Applicant Basis of Appeal HRPB #20-00100006

HRPB#20-00100081: An Appeal of the Historic Resources Preservation Board's decision to approve the construction of a new single-family structure at 403 South M Street

RE: Basis of Appeal
403 South M Street
HRPB 20-00100006

Figure 1 – Front Elevation 403 S M Street (As Proposed)

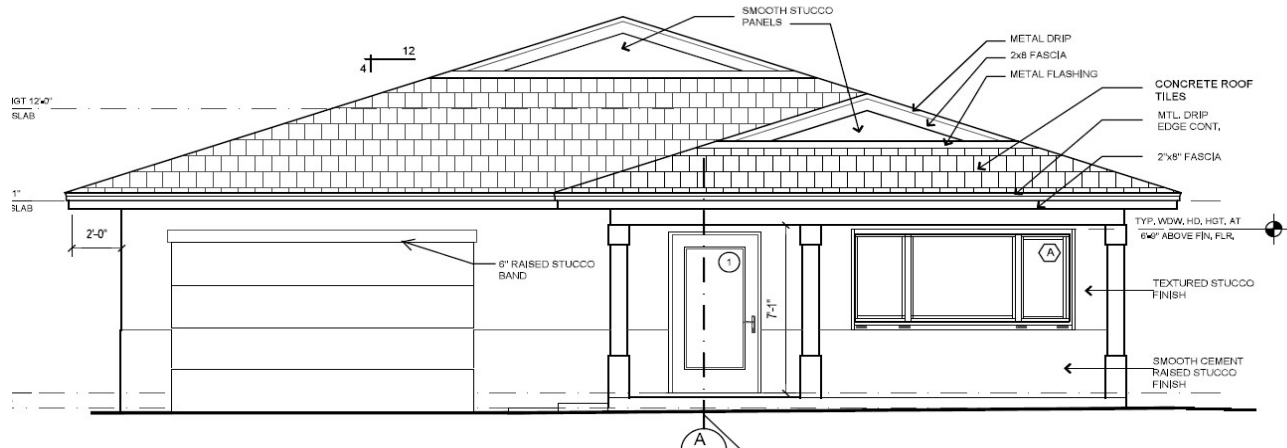
Condition 7 - The first of the two conditions which were arbitrarily included in the approval reads, “The front porch window and column configuration shall be changed to be symmetrical with two (2) vertically oriented single-hung windows with columns spaced evenly across.”

The drawing above (Figure 1) shows the proposed front elevation. The design of the porch and columns as well as the window were arrived at through careful consideration by the architect and applicant. Columns were placed at the desired locations along with the horizontal window with high sill to allow for furniture to be installed on the porch. A floor plan of the porch and column layout is provided below (Figure 2).

Figure 2 – Plan view of proposed front porch.

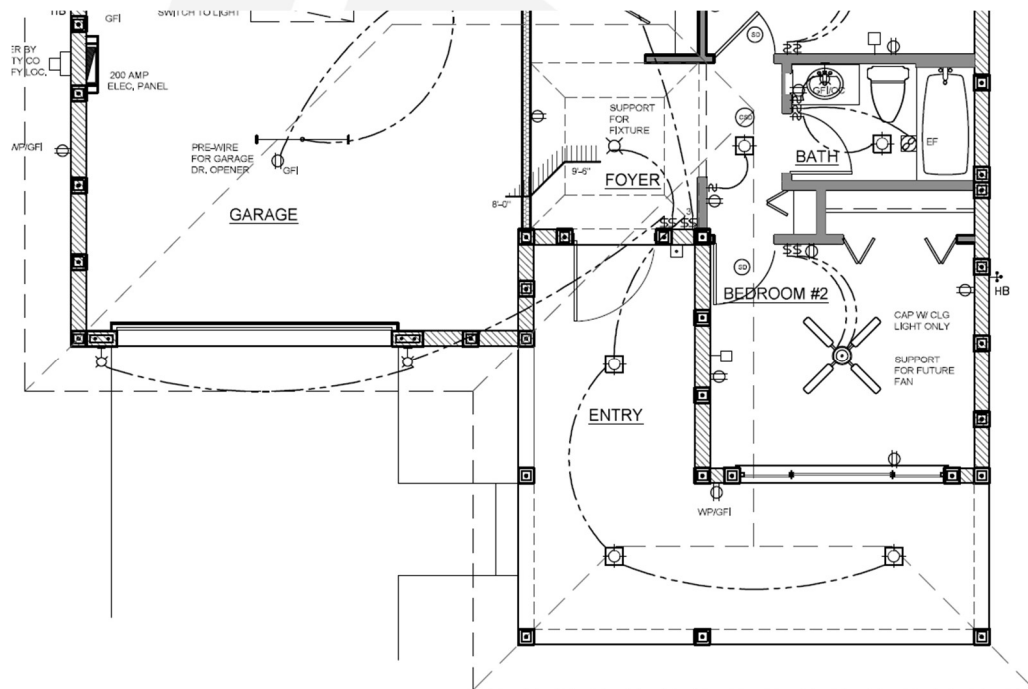
This condition was not part of the staff review comments and only originated during the board members discussion. The entire discussion occurred in minutes and without consideration of any historical relevance, neighborhood appropriateness, or city ordinances. Following this discussion, the board voted to replace the carefully considered design of the professional architect with their own aesthetic preference over the strenuous objections of the applicant.

This decision was arbitrary, if the board had reviewed the Historic Preservation Design Guidelines, they would have seen examples of both horizontally aligned windows and asymmetrical columns. In fact, the below drawing (Figure 3) is from Page 57 of the Historic Preservation Design Guidelines and is used to illustrate the style description for Masonry Vernacular construction. This drawing features a masonry building with both asymmetric columns and a horizontally oriented window.
